## **COCHRAN FAMILY**

## **RIVERSIDE ESTATE SUBDIVISION**

APPLICATION NUMBER 19 DATE December 6, 2012

REQUEST Subdivision

# DETAIL SITE PLAN

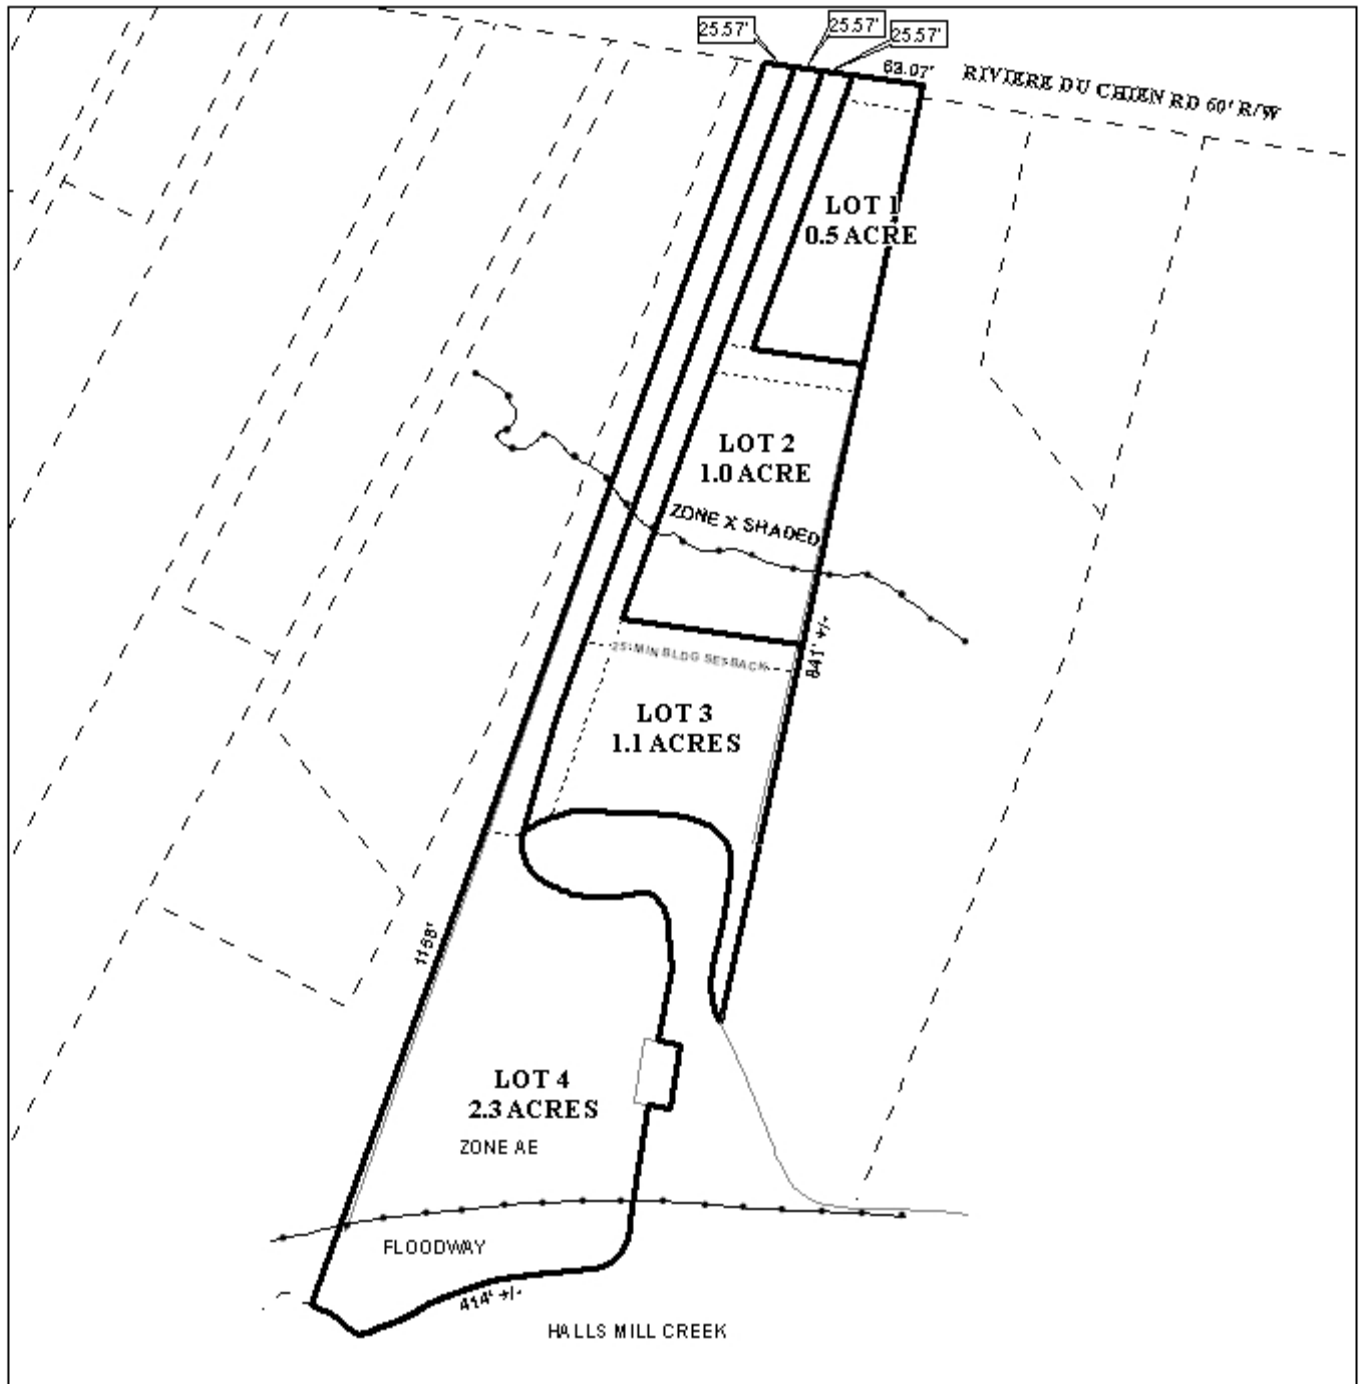
1. Label/show the existing common property line for lots 39 and 40A.
2. Provide all of the required information on the Final Plat (i.e. signature blocks, signatures, certification statements, legal description, required notes).
3. A signature for the Traffic Engineering Department shall be placed on the Final Plat.
4. Add a note to the Plat stating that storm water detention will be required for any unapproved development (since 1984) and any future addition(s) and/or land disturbing activity in accordance with the Storm Water Management and Flood Control Ordinance (Mobile City Code, Chapter 17 , Ordinance #65-007 & #65-045).

The site fronts onto Riviere Du Chien Road, a minor street lacking curb and gutter. The plat depicts a 60-foot wide right-of-way, however, information available to staff indicates that the right-of-way may be less than 60-feet. If the right-of-way is less than 60-feet, dedication sufficient to provide 30 feet from centerline should be required.

The applicant has requested two curb-cuts. The property has approximately 140 feet of frontage along Riviere Du Chien Road, which is slightly less than the normally desired 200 foot width for

two curb-cuts. That being said, division of the property into three 60-foot wide lots would typically result in three allowed curb-cuts. Therefore, the site should be limited to a total of two curb-cuts, as requested, with the size, design and location of all curb-cuts to be approved by Traffic Engineering and conform with AASHTO standards.

Each lot will meet the minimum area requirements for sites with public water and sanitary sewer, however the lot size in acres needs to be supplemented with the lot size in square feet.

The existing site exceeds the width to depth ratio of Section V.D.3. of the Subdivision Regulations, and all four proposed lots will also exceed this ratio. Additionally, three flag lots are proposed, which will require a waiver of Section V.D.1. Flag lots are, in fact, somewhat common along this stretch of Riviere Du Chien Road, primarily due to the proximity of Halls Mill Creek. Therefore a waiver of Sections V.D.1. and V.D.3. may be appropriate due to the fronting onto Halls Mill Creek, and the family subdivision nature of the request.

The 25-foot minimum building setback line, required in Section V.D.9., is depicted on the preliminary plat, but needs to be adjusted for Lot 4 so that it is located where the lot is a minimum of 60-feet wide.

It appears that the entire site is located within floodplains associated with Halls Mill Creek, and may also contain wetlands. The potential presence of wetlands and floodplains indicate that the area may be environmentally sensitive; therefore, the approval of all applicable federal, state and local agencies would be required for floodplain and wetland issues prior to the issuance of any permits or land disturbance activities.

- 1) Placement of a note on the final plat stating that the site is limited to a total of two (2) curb-cuts, with the size, design and location of all curb-cuts to be approved by Traffic Engineering and conform to AASHTO standards.

- 2) Revision of the 25-foot minimum building setback line to be located where each lot is a minimum of 60-feet in width (specifically Lot 4), as required by Section V.D.9. of the Subdivision Regulations;

- 3) The labeling of each lot with its size in square feet, or placement of a table on the plat with the same information;
- 4) Compliance with Engineering comments (*The following comments should be addressed prior to review, acceptance and signature by the City Engineer: 1. Label/show the existing common property line for lots 39 and 40A. 2. Provide all of the required information on the Final Plat (i.e. signature blocks, signatures, certification statements, legal description, required notes). 3. A signature for the Traffic Engineering*
